March 25, 2020

Re: Riverkeeper, Inc. comments regarding the Proposed License Transfer of Indian Point Energy Center (Docket Nos. 50-3, 50-247, 50-286, 72-051)

INDIVIDUAL UNIT 1 STRONTIUM FLOW PATH LOCATIONS

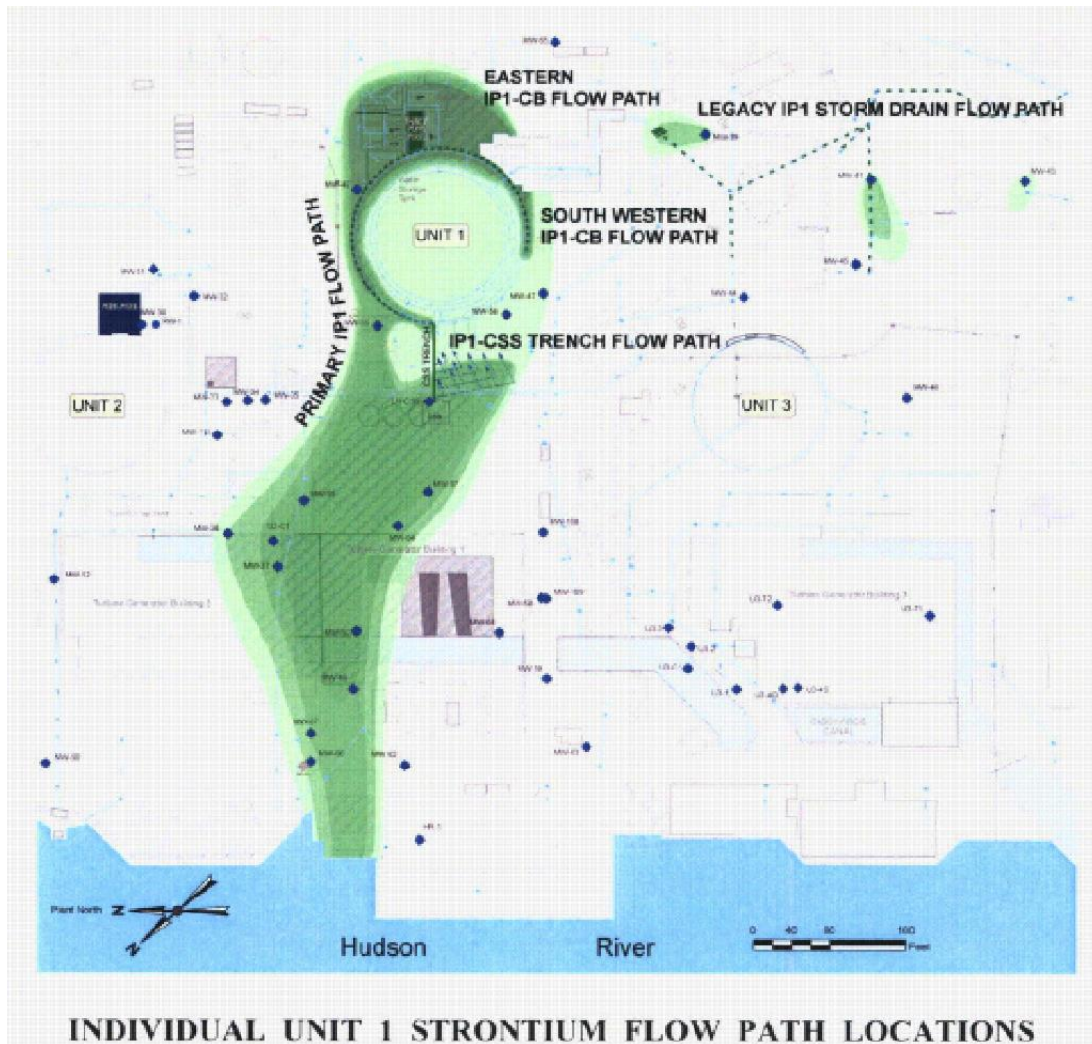
easier access routes. All of these changes could invalidate the assumptions upon which the LTMP rely. The PSDAR assumed that the existing LTMP as-is would continue to function adequately throughout decommissioning without justifying why activities could not undermine its effectiveness.

The monitoring well locations (represented by blue dots in the figure) and the depths of sensors installed in the locations relied on the existing hydrogeological conditions and the assumption of a groundwater recharge rate of 10 inches per year. If decommissioning activities alter the onsite groundwater flow paths or increase the recharge rate, the LTMP may be adversely affected. The report on the hydrogeological evaluation report expressed the limitation of its assessment:

INDIAN POINT 2

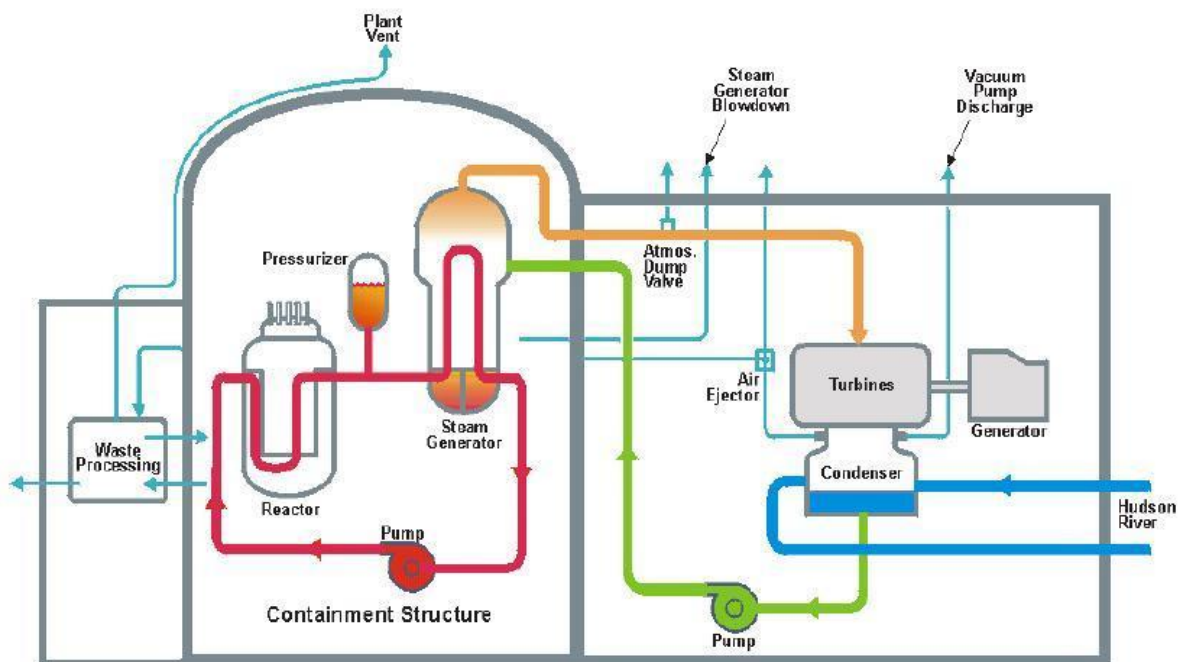
The turbine and condenser to be segmented using “appropriate radiological precautions” are shown on the right side of the Indian Point 2 schematic. The main steam pipes (orange line) carry steam from the steam generators housed within the containment structure to the turbine. The condensate and feedwater pipes (green line) recycle water from the condenser back to the steam generators. Called the secondary loop, these pipes and components are normally “clean” radioactively. But, as the PSDAR stated, the rupture of a tube within a steam generator in February 2000 allowed radioactively contaminated water to leak, flash to steam, and get transported to the turbine and condenser and contaminate them radioactively.

If the tube had not failed, the Unit 2 turbine and condenser would presumably not be contaminated with radiation. Yet, whether the tube leaked or not, the radioactively contaminated water (red line) flowing through the Unit 2 steam generators that day — and literally thousands of days before and after that day in February 2000 — would have subjected those steam generators to radioactive contamination. If one leaking tube on one day compels “appropriate radiological precautions” for the Unit 2 turbine and condenser, it seems grossly inappropriate for the Unit 2 (or Unit 3 for that matter) steam generators to be removed without “appropriate radiological precautions.” Yet the PSDAR was silent on the subject, other than to mention the steam generators would be removed. That description provided the NRC with no useful information to properly develop and apply its oversight efforts.
